INDESIT company

BCB313AAVEIS/HA

F048756

52220R0 Exploded views

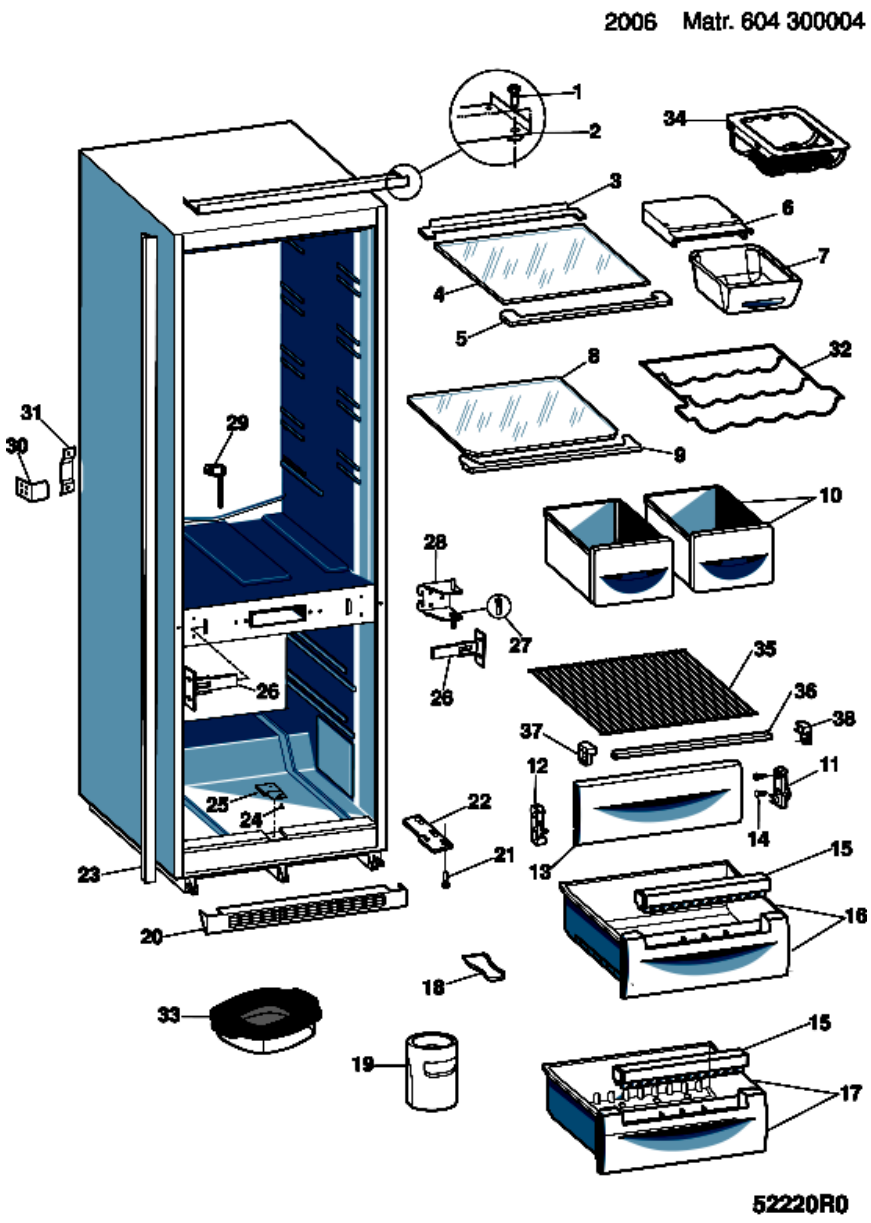
n3010j01: Colour Change of Internal Accessories

The colour of some of the internal shelves and accessories have changed to transparent. This affects models produced in Carinaro-

Manisa. Modification is functionally interchangeable therefore once the colour versions of the parts have depleted they will automatically substitute to its corresponding transparent parts. Some parts will have been made obsolete with no substitution.

Some parts have changed from Satin Finish to Shiny (Crystal) Finish. These parts include;
-Door Shelves
-Crisper Front Panels
-Freezer Drawer Front Panels
All pre-modification components will be managed till the end of stock and after they will be substituted with new version.
